CERTIFICATE OF APPROPRIATENESS

Property: 1212 Tulane Street, Lot 27, Block 183, Houston Heights Subdivision. The property includes a historic 1,580 square foot, 1½-story wood frame single-family residence situated on a 4,400 square foot (33' x 132') interior lot.

Proposal: Alteration – Construct a rear two-story 1,621 square foot addition to a 1½- story 1,680 square foot single-family residence. The addition will begin at the rear wall and will measure 24'-3" wide, 41'-10" deep, 10'-6" to the eave, and 26'-1"to the ridge.

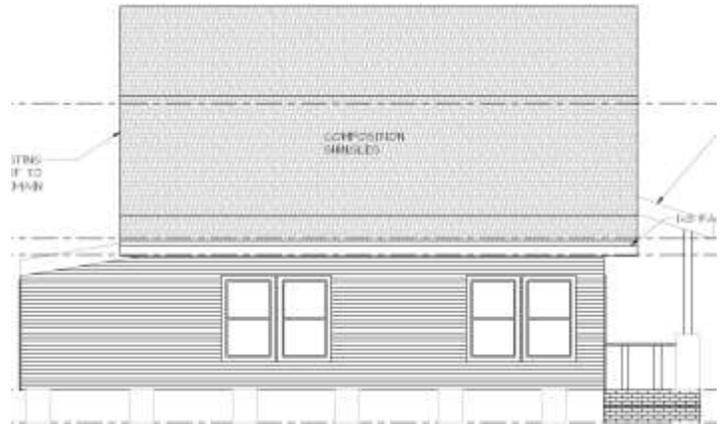
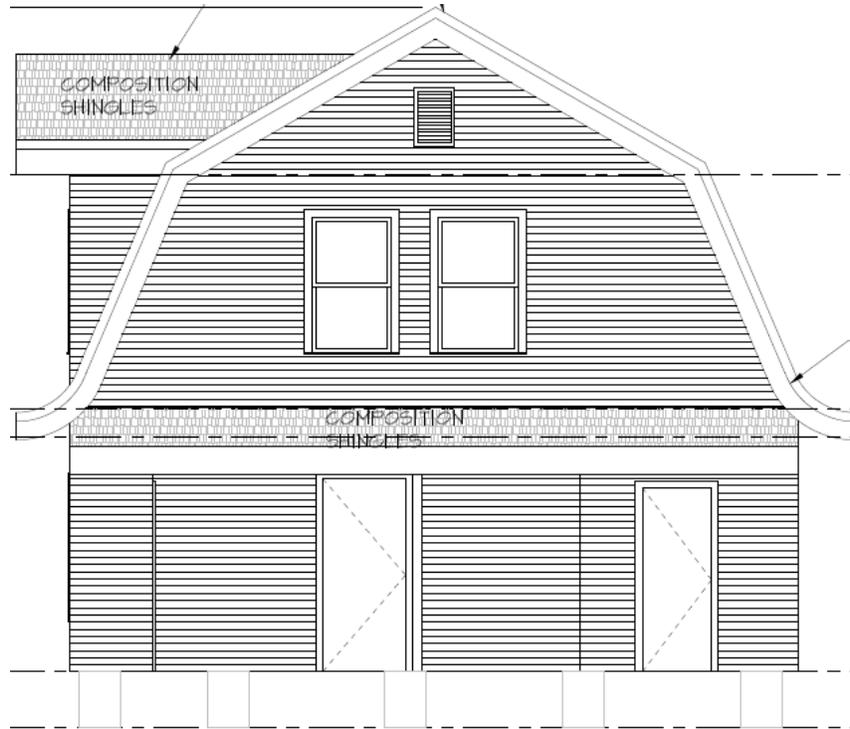
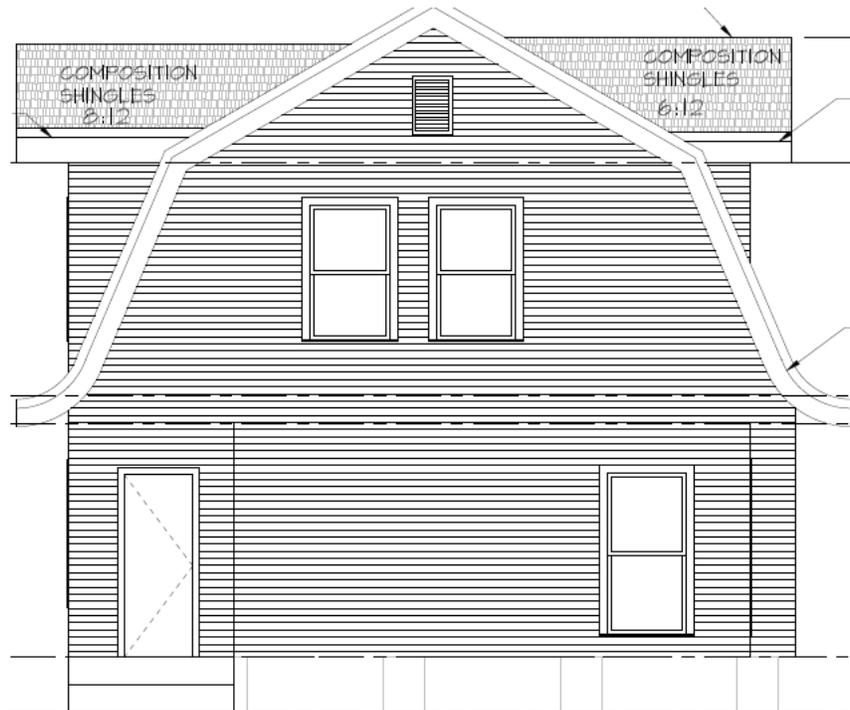
This contributing structure is very unique and every attempt should be made to save it intact. While there is evidence of the need for significant repair, the charm of the gambrel roof and the flip-up wave at the end of the cornice is very unique and should be maintained and celebrated. The addition should occur behind the existing structure with a “dash” connection between the existing and the proposed addition.
